## NOVI CORPORATE CAMPUS PARCEL 2 JSP14-60

Public hearing at the request of Dembs Development, Inc for the approval of the Preliminary Site Plan, Wetlands Permit, Woodlands Permit and Stormwater Management Plan. The subject property is located in Section 9, north of Twelve Mile Road, east of West Park Drive in the I-1, Light Industrial District. The current submittal, Novi Corporate Campus Parcel 2, is approximately 4.85 acres and the applicant is proposing to build a one-story 52,500 square foot speculative office/warehouse building with accessory parking facilities on Lot 2 in the Novi Corporate Campus development.

**PLANNING REVIEW**

**SUBJECT: Novi Corporate Campus Parcel 2, Traffic Review for Preliminary Site Plan  
JSP14-0060**

**SITE PLAN**

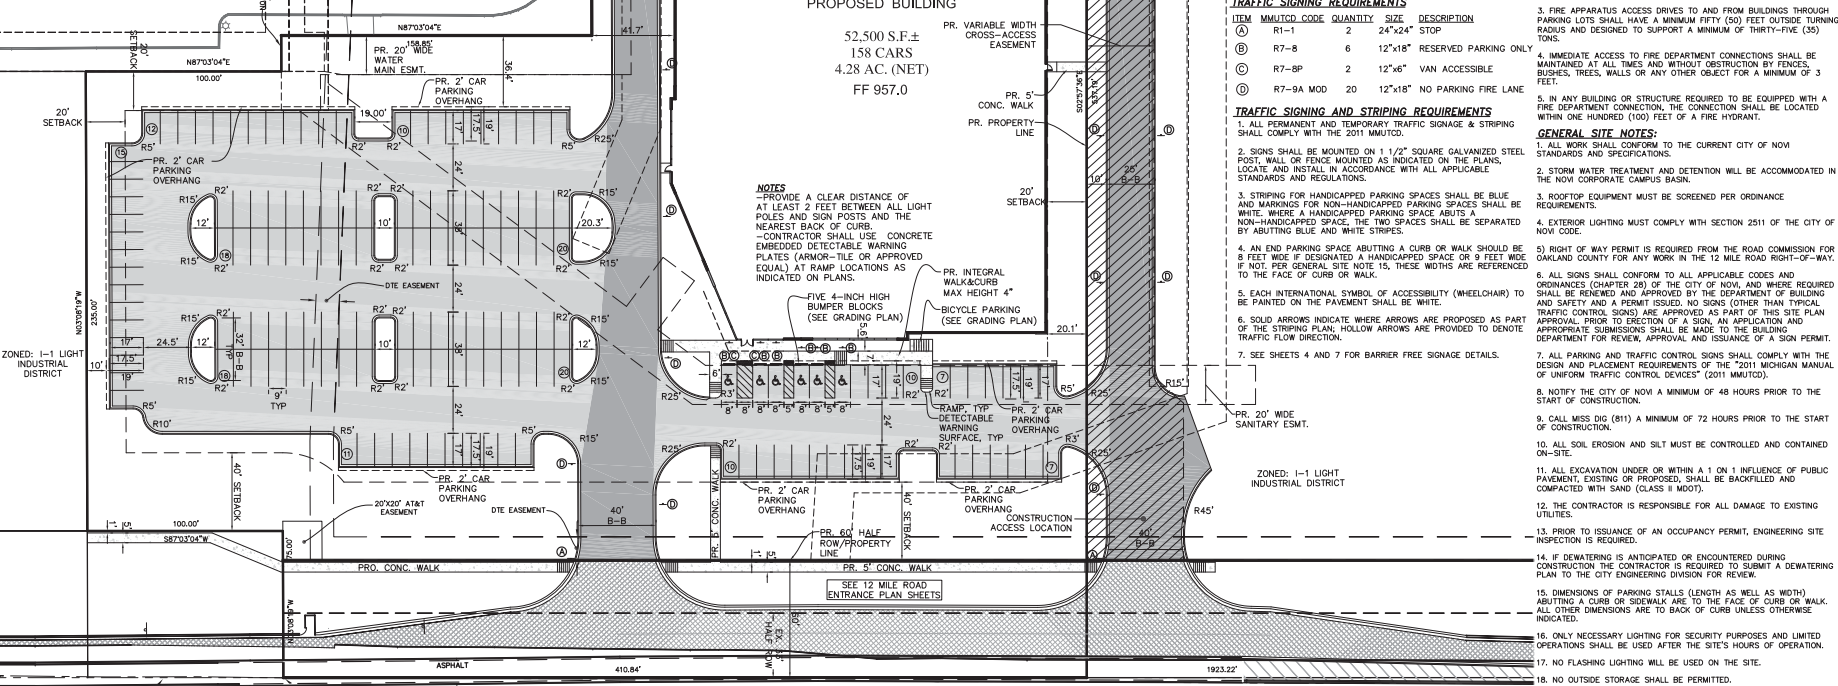
Approval of the *Preliminary Site Plan is recommended*. The plan generally conforms to the requirements of the Zoning Ordinance; however there are **façade, traffic, wetlands and woodlands and landscape related items to be addressed on next Site Plan submittal**. Planning Commission approval of the Preliminary Site Plan is required.

The Preliminary Site Plan meets the general requirements of Chapter 11, the Storm Water Management Ordinance and the Engineering Design Manual with the following items to be addressed at the time of Final Site Plan submittal (further engineering detail will be required at the time of the final site plan submittal):

- a. Clearzoning comment 4 recommended the inclusion of a left turn lane for eastbound traffic into the site. The City standard taper length for dropping a center left turn lane is 300' per the City's Design and Construction Standards Figure IX.7. The applicant is proposing a taper length of 540'. The applicant should include additional comments regarding why the 540' taper is being proposed instead of a 300' taper.

- d. The applicant should consider detailing the existing pavement markings to indicate what will be removed as part of this project. The applicant should also consider adding more detail to the proposed striping plan.

2. The building square footage listed within the building envelope (52,500 SF) will be revised on the Final Site Plan drawings to match the square footage under site data (64,840 SF).
3. A lighting and photometric plan compatible with the surrounding development will be provided with the Final Site Plan submittal.

- 2a. An extension of the existing left turn lane at West Park Drive is proposed beyond the centerline of the proposed east access drive, followed by a 540 foot long taper back to the one lane section further east since the existing conditions do not permit widening on both sides of the Road.
- 2b. Proposed signage will be shown on the Final Site Plan.
- 2c. Detailed ramp grading will be provided at Final Site Plan.
- 2d. Additional detail will be provided on the existing pavement markings to be removed and proposed pavement markings at Final Site Plan.
